Access Compliance Report Public Rights-of-Way (Pedestrian Signals)

Main Street: FUTURA_DR Cross Street: FAIRMONT_BLV Location: NE

ADA ID: SGAT210921152941 Signal Type: One Push Button-Non APS Overall Compliance: No Severity Scores: BTN 1: 35 BTN 2: N/A No BTN: N/A

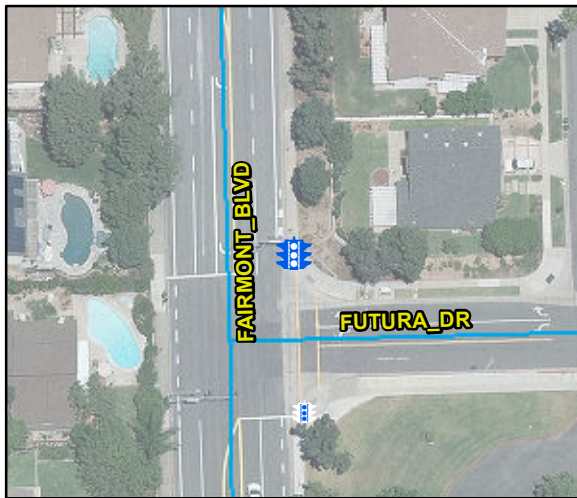
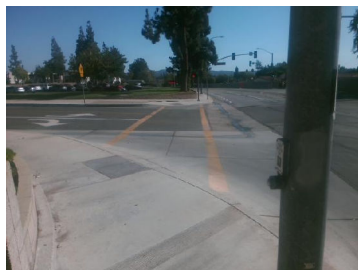
OC Std/PROW: R404.2, MUTCD 4e.08

Possible Solutions: Replace Signal Push Button With APS Button. Remove and Replace Clear Space.
